## ANN ARBOR HISTORIC DISTRICT COMMISSION

### Staff Report

**ADDRESS:** 511 Elizabeth Street, Application Number HDC17-195

**APPLICATION:** The applicant seeks HDC approval to enlarge a basement window and install a wider and taller egress window.

511 Elizabeth (September 2014, ©Google streetview)

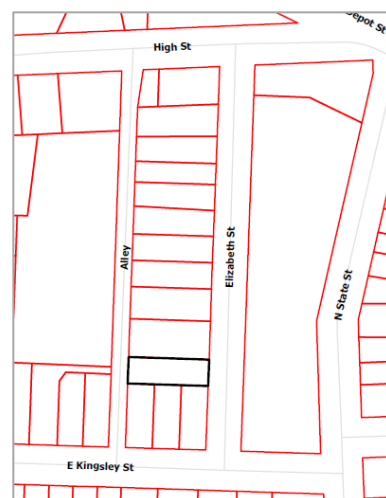
2. A basement window on the north elevation of the house, in front of the brick chimney, is proposed to be enlarged from a 31" wide and 21" tall masonry opening to a 36" wide by 55" tall opening. About 36" of the window would be below grade. A window well would be made of 6" by 8" landscape timbers. The drawing and a photo of a similar well indicate a base of 36" by 36" and a top opening of 40" by 40".
3. The replacement of the window to the west, behind the non-original chimney, would be more appropriate than this one near the front of the house, though it would be only marginally less visible. Any conversion of the basement to sleeping space will require the expansion of a historic window opening. Staff believes the north side of the house is marginally less visible than the south side, and therefore better suited to an egress window.

I move that the Commission issue a certificate of appropriateness for the application at 511 Elizabeth Street, a contributing property in the Old Fourth Ward Historic District, to replace two rear windows with larger rear windows, as proposed. The work is compatible in exterior design, arrangement, texture, material and relationship to the rest of the building and the surrounding area and meets the *Ann Arbor Historic District Design Guidelines*, especially those for windows and safety codes, and the *Secretary of the Interior's Standards for Rehabilitation and Guidelines for Rehabilitating Historic Buildings*, in particular standards 2, 9 and 10 and the guidelines for windows, neighborhood setting, and health and safety.
